Access Compliance Report

Public Rights-of-Way

(Curb Ramps)

Intersection ID: 13877	Main Street: MYRTLE_AV	Cross Street: TEMPLETON_AV	Location:	N
ADA ID: 2F3564CA8288	Ramp Type: PerpDiag	Initial Pass/Fail: Fail	Overall Compliance: No	Severity Score: 12.5
Codes/Mitigation Info/Possible Solution		Field Measurements/Component Compliance

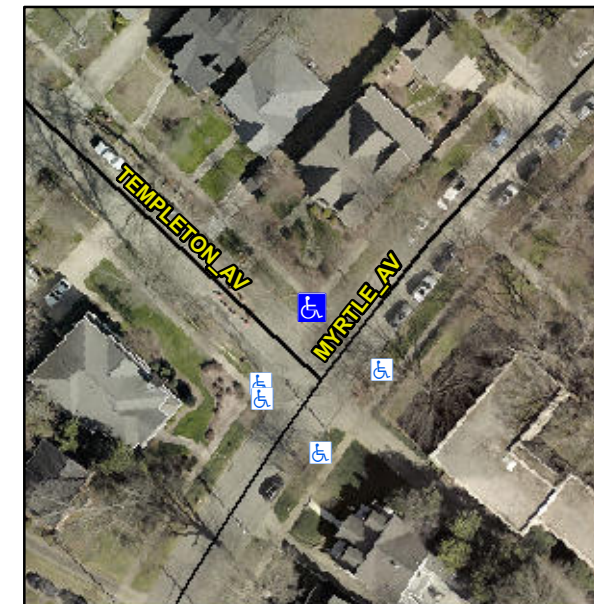
Not Found, R304.2.2

Compliance	Description	Data	Compliance	Description	Data
N/A	Ramp Length (in)	83.0	No	Ramp Slope (%)	9.1
Yes	Ramp Width (in)	60.0	Yes	Ramp XSlope (%)	1.0
N/A	Flare Type LT	N/A	N/A	Flare Type RT	N/A
N/A	Flare Slope LT (%)	N/A	N/A	Flare Slope RT (%)	N/A
N/A	Flare Traversable LT?	N/A	N/A	Flare Traversable RT?	N/A
N/A	Landing Length (in)	N/A	N/A	DWS Provided?	N/A
N/A	Landing Width (in)	N/A	N/A	DWS Contrast?	N/A
N/A	Landing Slope (%)	N/A	N/A	DWS Length (in)	N/A
N/A	Landing X Slope (%)	N/A	N/A	DWS Full Width?	N/A
N/A	Landing Curb? (Y/N)	N/A	N/A	DWS Offset (in)	N/A
N/A	Shared Landing?	N/A			
N/A	Gutter Ponding?	Yes	N/A	Gutter Slope (%)	N/A
N/A	Gutter Lip Ht (in)	N/A	N/A	Gutter X Slope (%)	N/A
N/A	Painted X Walk1?	No	N/A	Painted X Walk2?	No
	X Walk 1 Direction	To SW		X Walk 2 Direction	To SE
N/A	X Walk 1 Width (in)	N/A	N/A	X Walk 2 Width (in)	N/A
	X Walk 1 Slope (%)	2.6		X Walk 2 Slope (%)	2.0
	X Walk 1 X Slope (%)	0.6		X Walk 2 X Slope (%)	1.5

Remove & Replace Curb Ramp With Two New Directional Ramps or Equivalent.
